SUBJECT: Forwards comparison of draft STS w/snubber functional test sampling plan.

Re: Snubber Functional Test
Sampling Plan

SNUBBER FUNCTIONAL TEST
SAMPLING PLAN EVALUATION

Dev./Station _____ Unit _____ File No. _____
 Subject Confidence Limits of Sampling Plans

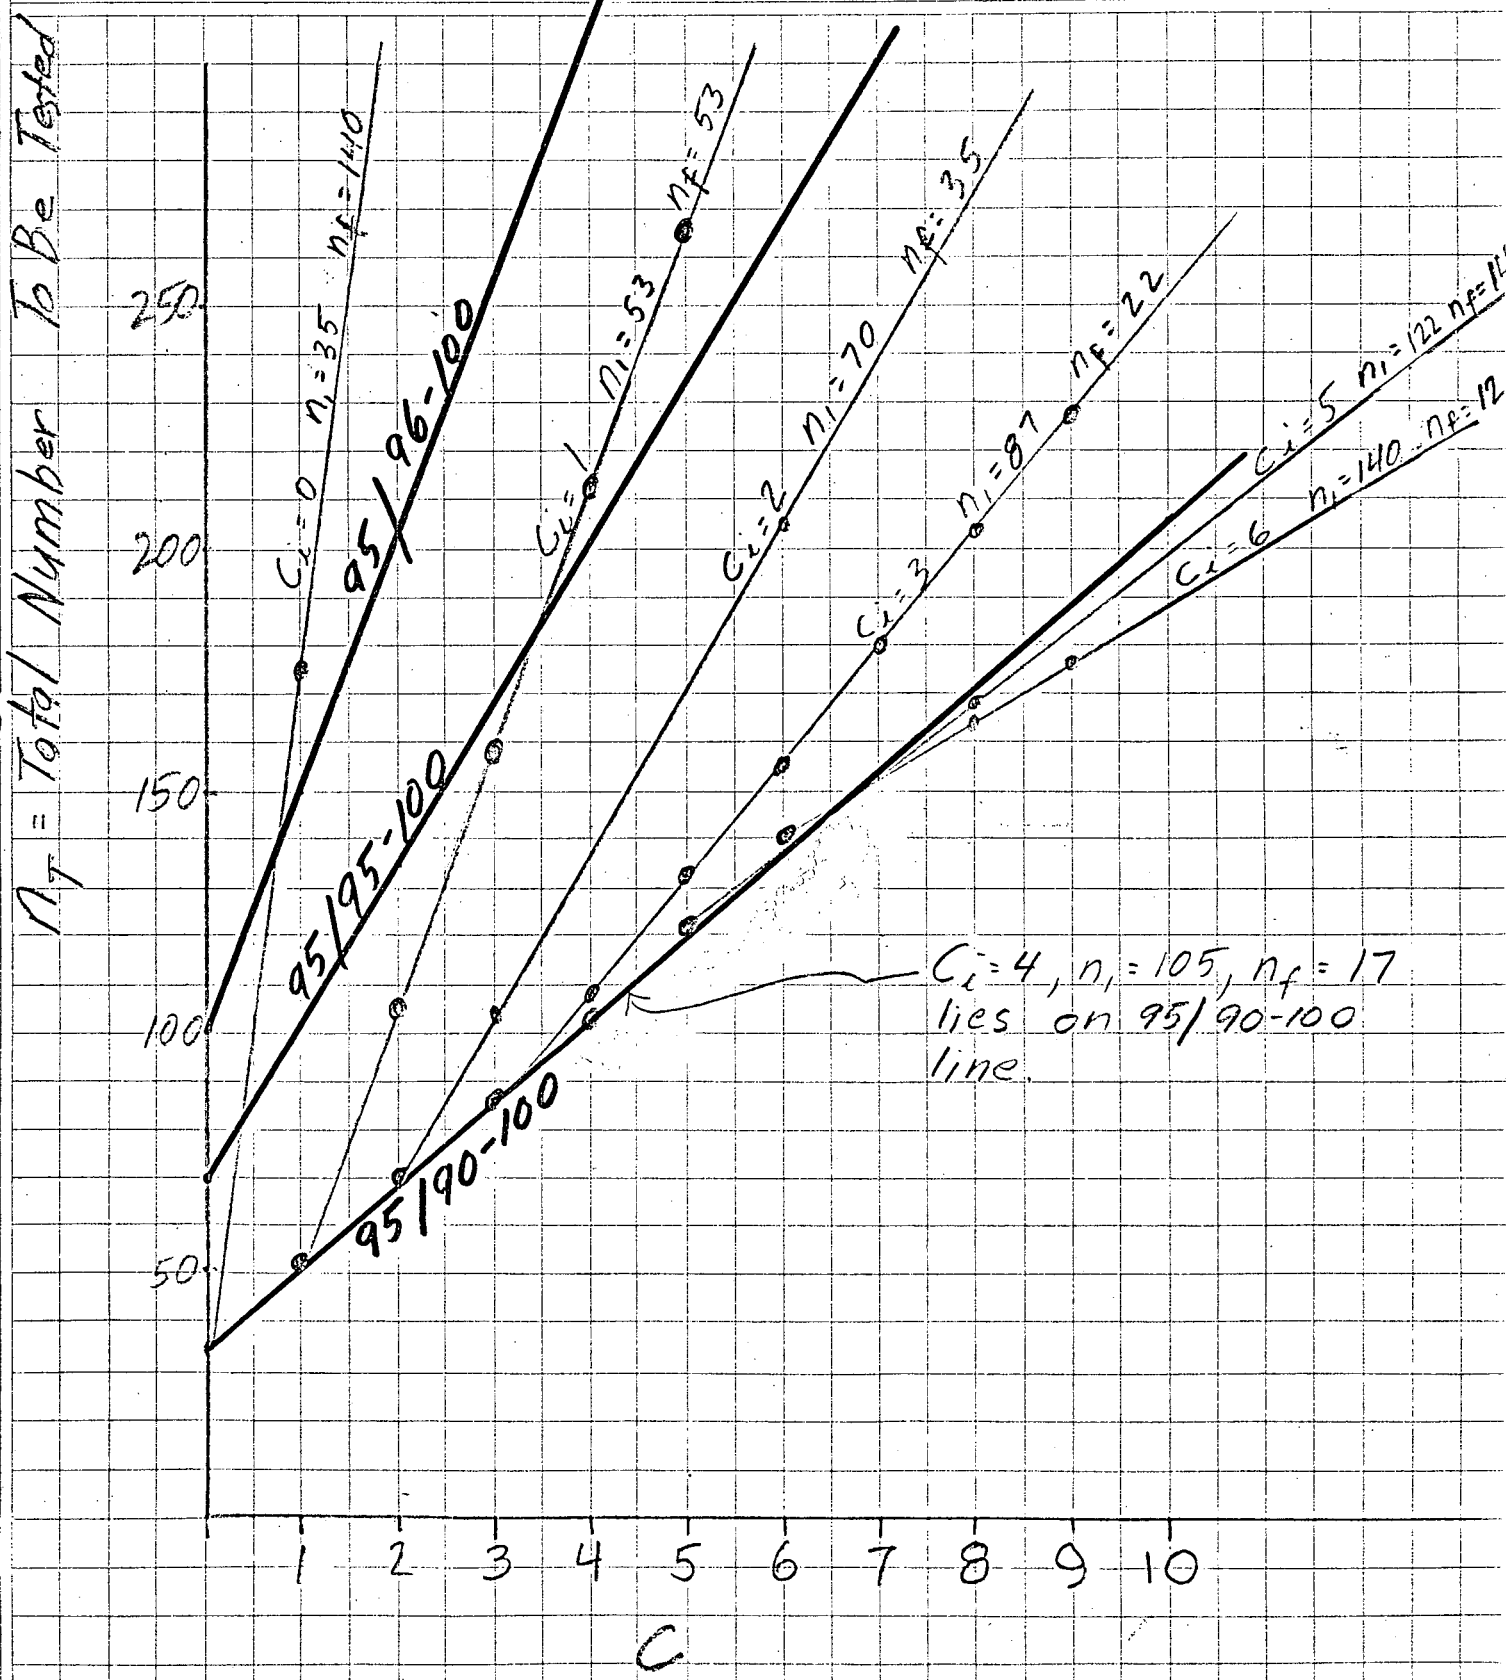
The first step in making an evaluation of these plans is to narrow the draft plan down to its viable alternatives. All initial values of c (c_i) greater than 4 have very large initial samples and do not provide adequate levels of protection if follow-on samples are required. Therefore, these c_i are not viable and will not be considered further. This relationship is shown in Figure 1.

Probability of Passing Bad Lot on First Test

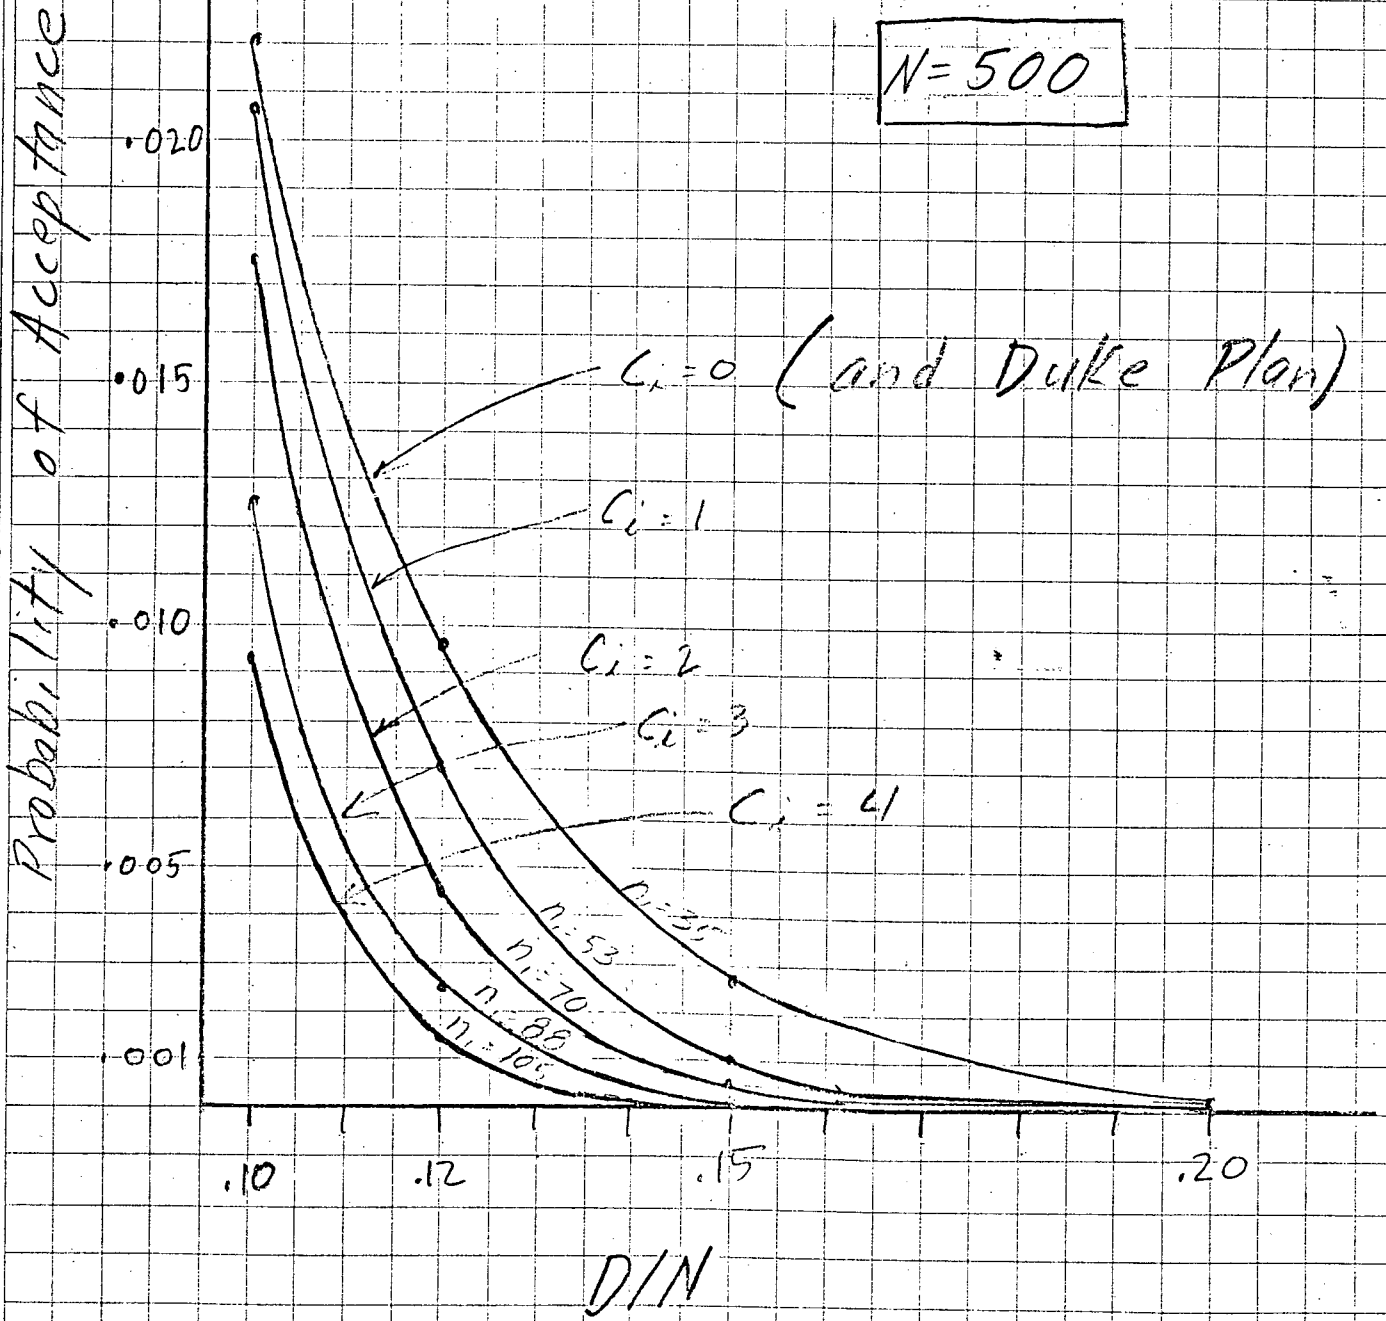
Figure 2 shows the probability of accepting populations of 10% or more out of calibration snubbers for various initial values of c . The Duke plan corresponds to $c_i = 0$. As can be seen, the probability⁽²⁾ of accepting bad lots decreases with increasing c_i . In all cases, the probability of accepting a bad lot is very small. For example, a population of 500 snubbers that is marginally acceptable ($D/N = .10$) will be accepted only about two times in 100 under the most liberal plan. A clearly unacceptable population with 20% out of calibration snubbers ($D/N = .20$) will be accepted only about three times in 10,000 under the most liberal plan.

Our conclusion is that all sampling plans reject bad lots with a high degree of confidence, but that the draft plans are marginally better at this than the Duke plan.

Probability of Accepting Good Lots on First Test

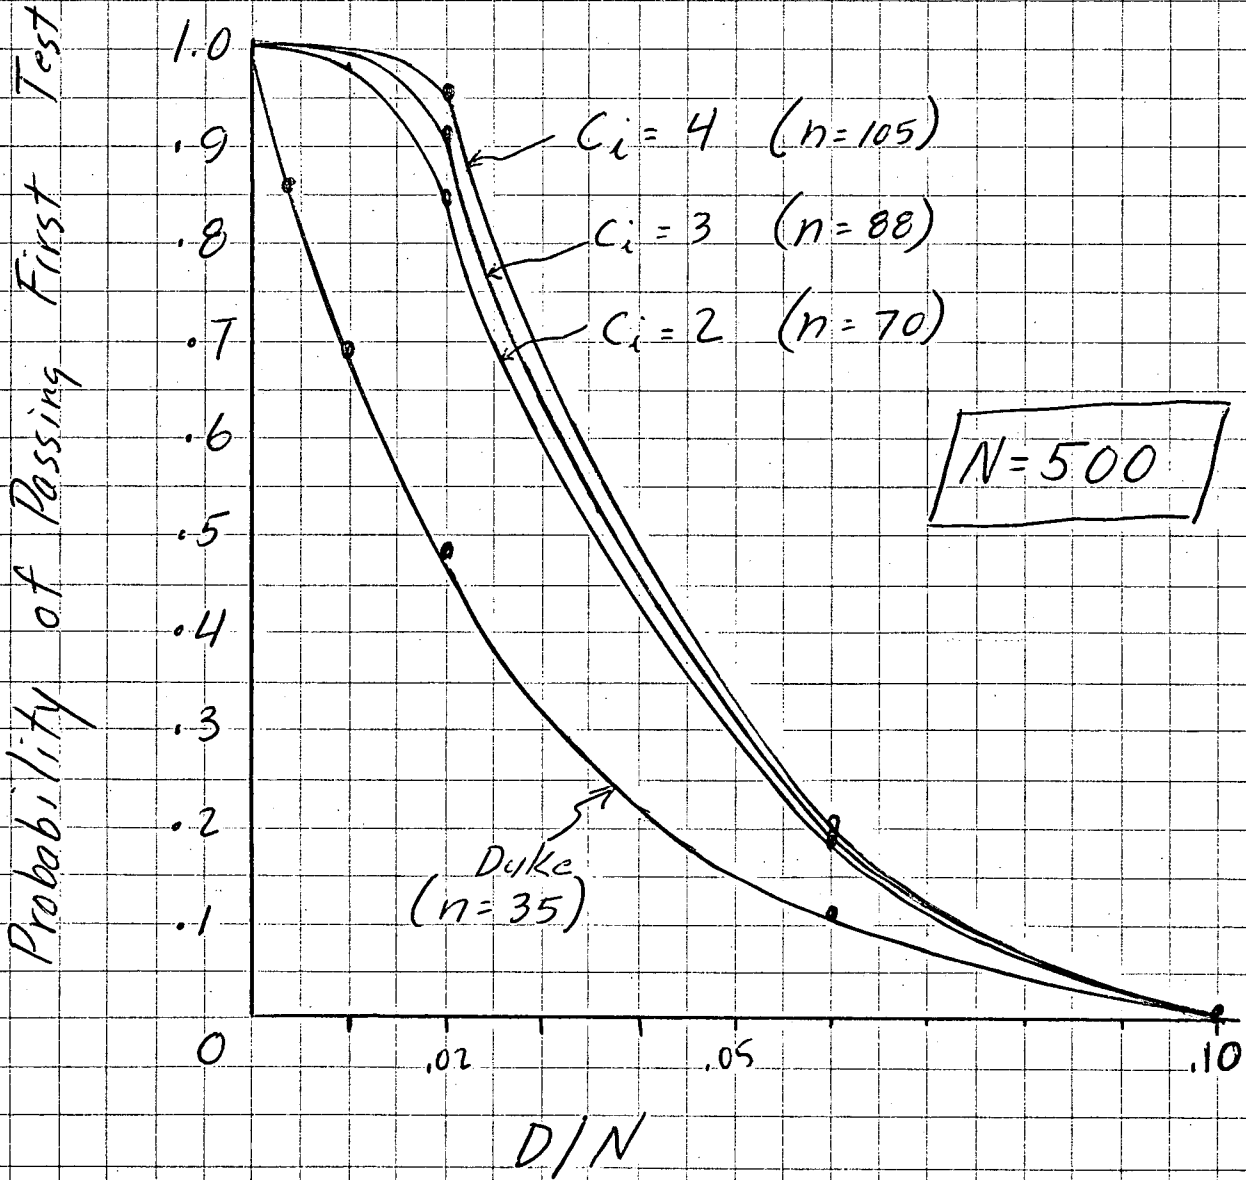
To have a reasonable chance of passing the first test under any plan, the population must be considerably better than the acceptance criteria. Figure 3 shows this relationship for the plans under consideration. For a population of 500 snubbers, to have a 50-50 chance of passing the first test, the population must have fewer than 4% out of calibration snubbers. For purposes of further comparison, we will take a "good" population as one with 2% out of calibration snubbers ($D/N = .02$).

Probability of Accepting Good Lot After Testing Given Number

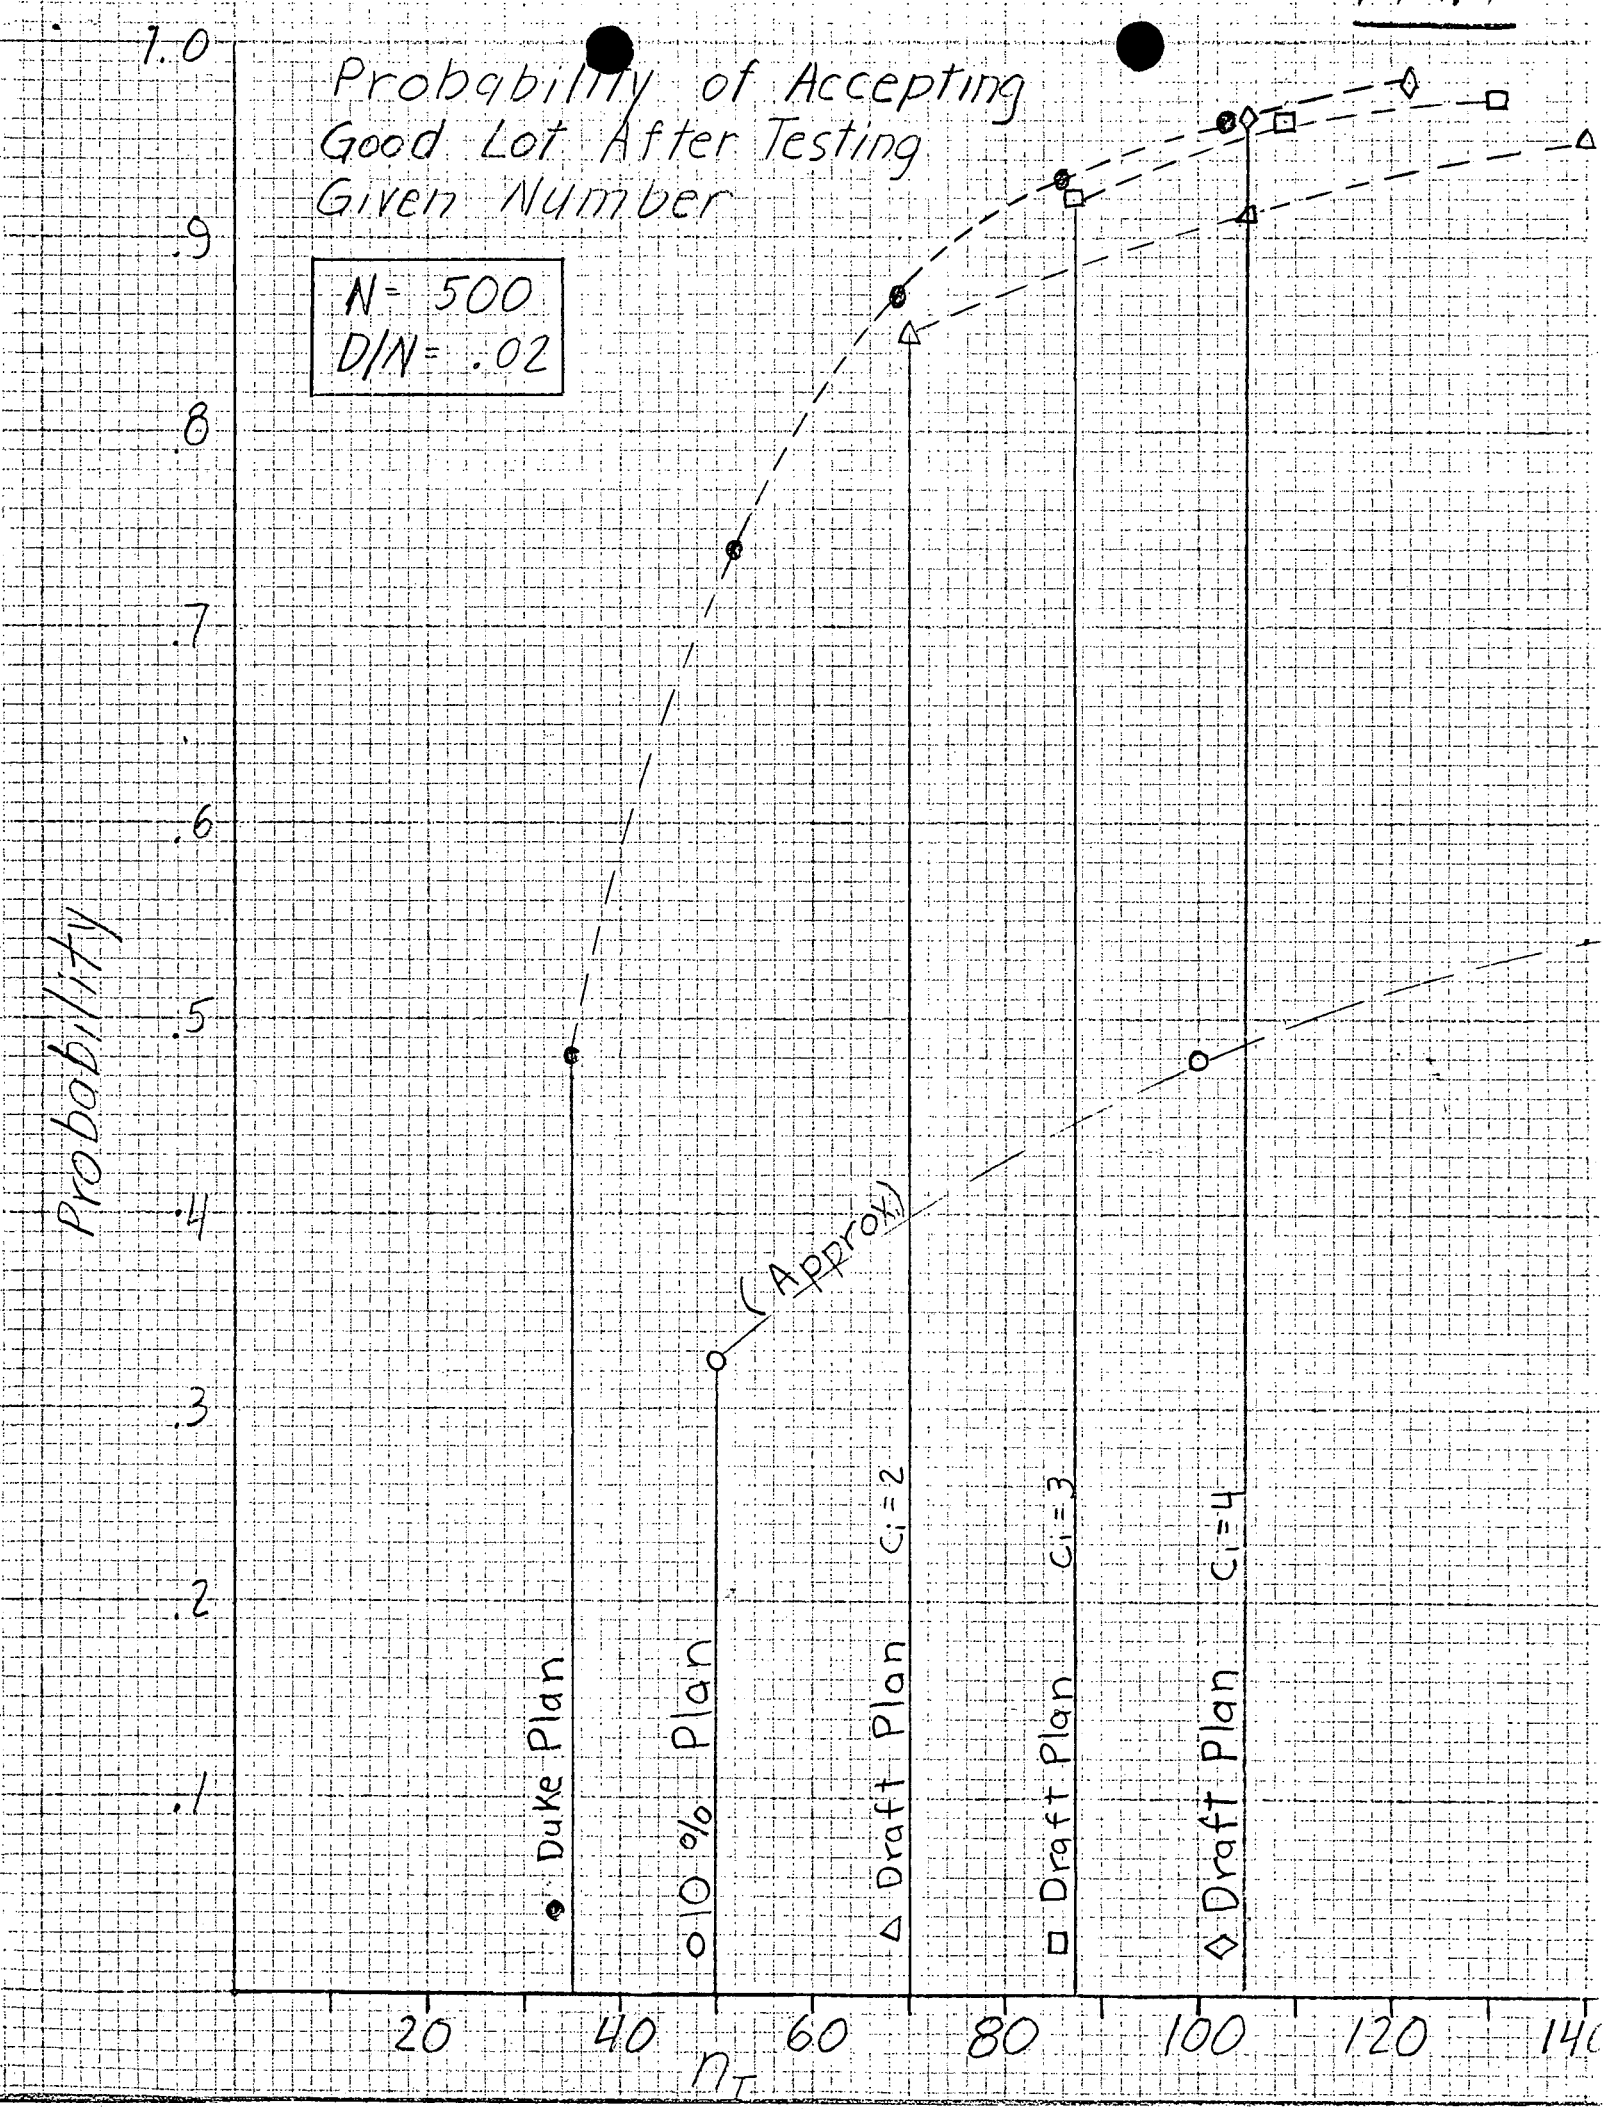
Figure 4 plots the probability of acceptance versus the cumulative number of snubbers tested. The Duke plan exceeds the draft plan in probability of accepting good lots for $c_i = 2$ and $c_i = 3$, and appears to roughly coincide with $c_i = 4$ in this respect. (For information, an approximation of the 10% plus 10% sampling plan is included to show that it operates poorly on large populations.)

Our conclusion is that all plans under consideration are capable of accepting good lots with a high degree of confidence. However, for any given number tested, the Duke plan is somewhat more efficient than the draft plans.
